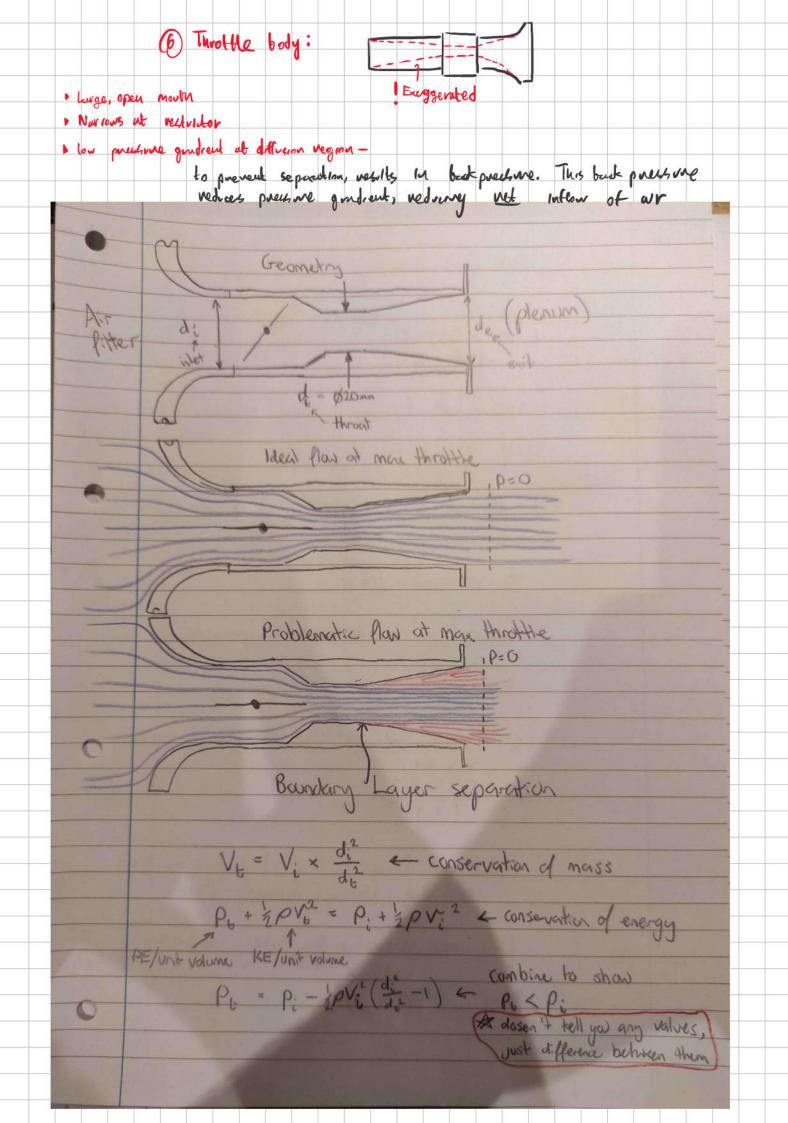
While 290mm is an upper bound for the runner length, this does includ the curved path length of the injecto holders as well. Overall then, the length limit is lower.

From the simulations, there i a greater drop-off at high end (high RPM) torque for longer lengths, so actually a shorte runner length is better.

Effective cross-sectional area facing in direct air flow is also an issue- try to keep this fixed, but avoid making the angle any further vertical.

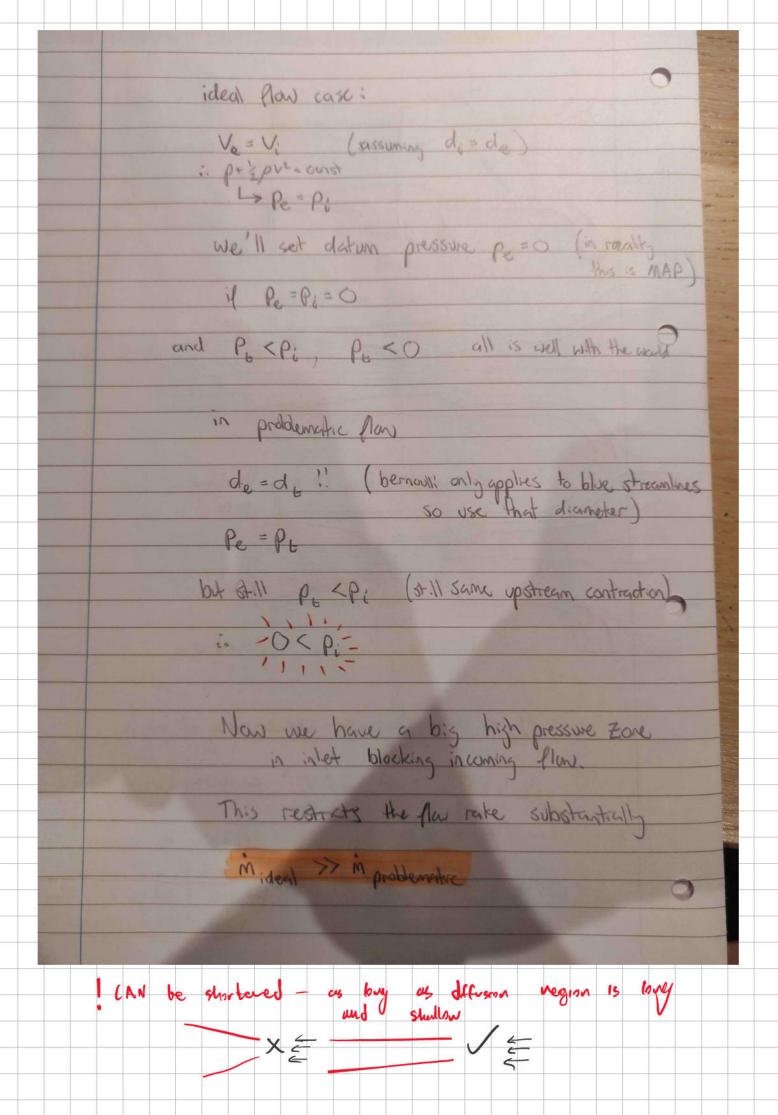
Relevant for 'ram' air effect.

Consider some variable which is the horizontal overhang of the thrrottlebody an air filter in front of the rear roll hoop plane.

We can select a geometry, such that adjusting a variety of parameters: Runner straight section length, injector holer bend radius, Plenum longitundinal length etc... gives the following outputs: (1) Overhang in x in front of rollhoop (2) Vertical height of throttlebody mouth
